STAFF REPORT: FEBRUARY 7, 2024, REGULAR MEETING
APPLICATION NUMBER: HDC2024-00027
ADDRESS: 450 AND 461 ELIOT
HISTORIC DISTRICT: BRUSH PARK
APPLICANT: JOHN P. BIGGAR, STUDIOZONE, LLC
PROPERTY OWNER: ELIOT STREET LOFTS, LLC
DATE OF PROVISIONALLY COMPLETE APPLICATION: JANUARY 12, 2024
DATE OF STAFF SITE VISIT: JANUARY 24 AND FEBRUARY 1, 2024

SCOPE: REMOVE CANOPIES, ALTER WINDOW AND DOOR OPENINGS

North-facing canopy (located on original, 1912 building) proposed for removal. No replacement is proposed. January 2024 photo

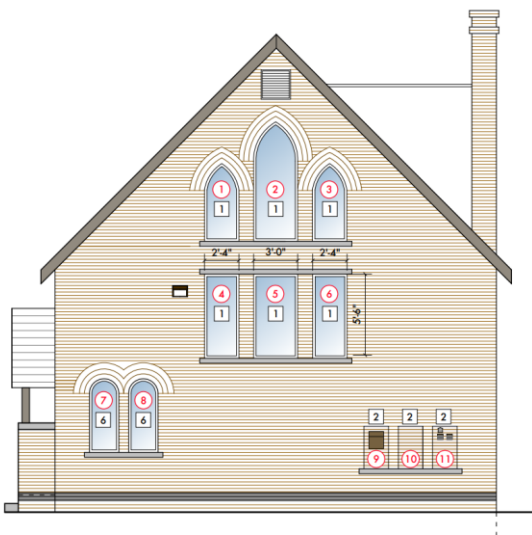
- The canopy on the north façade (i.e., the original 1912 building) of 450 Eliot appears to be an original or historic feature and is important to the building’s character. Its curved, oversized brackets and arched overhang are consistent with the Arts and Crafts-influenced style of the building. The materials used also appear to date from the early twentieth century.

- The removal of the north-facing canopy on 450 Eliot would remove a historic, character-defining feature. It would also create the condition of an uncovered primary entrance, inconsistent with the Arts and Crafts style of the building and the Brush Park Elements of Design. The work would be contrary to the Secretary of the Interior’s Standards for Rehabilitation, namely Standard #2: “the removal of historic materials or alteration of features and spaces that characterize a property shall be avoided.”
- Materials and specifications for the proposed stained-glass windows are not provided.

Staff concludes that the proposed removal of the north-facing canopy on 450 Eliot is inappropriate for the reasons listed below.

- The north-facing canopy is a character-defining feature that should not be removed. If elements are deteriorated beyond repair, they should be replaced in kind.

Therefore, staff recommends that the Commission issue a *Denial* of those work items as they do not meet the Secretary of the Interior's Standards for Rehabilitation, in particular:
